Determination 2015/055

Regarding the code compliance of building work in a new house at 124 Navigation Drive, Whitby, Porirua

A.2 The relevant Figure from Acceptable Solution E2/AS1 includes:

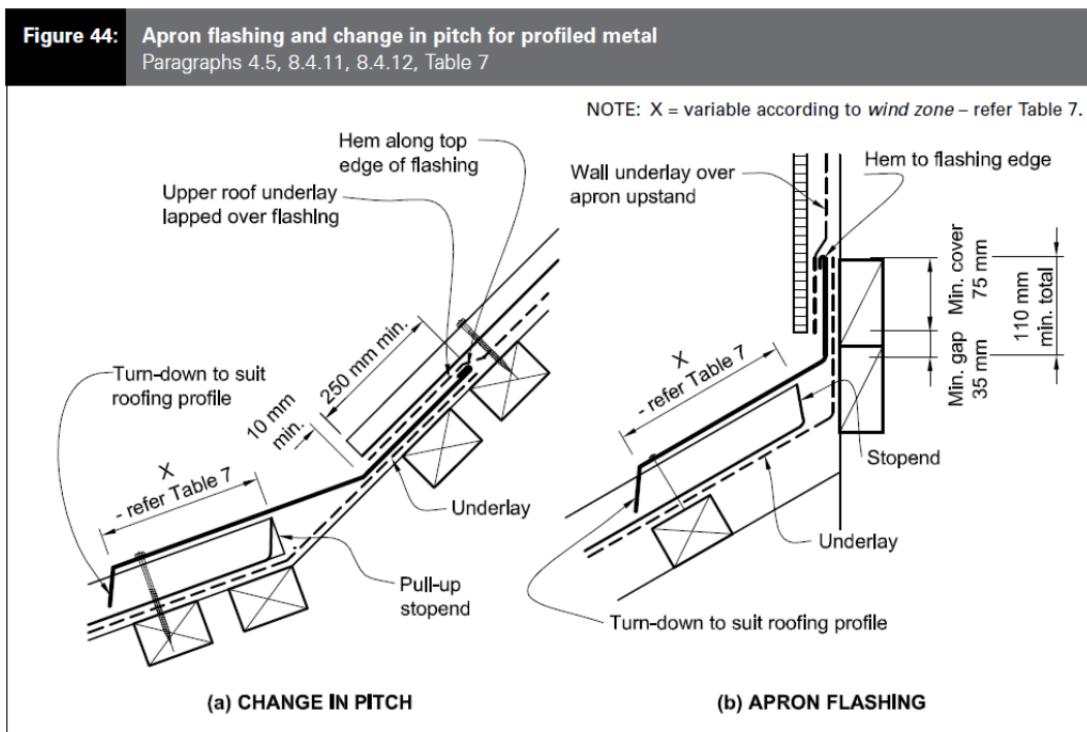
- 5.4.1 The consented detail for the roof/veranda junction is similar to Figure 44 in the Acceptable Solution E2/AS1 (refer Appendix A); however, the detail is inconsistent with other drawings provided in the consent application. Functional features of the

drawn detail, such as the turn up at the ends of profiles and the use of underlay, could not or would not be used with the polycarbonate sheets specified in other drawings. Without alternative features, the design of the detail in the consent application was incomplete and could not be relied on to provide a weathertight junction.
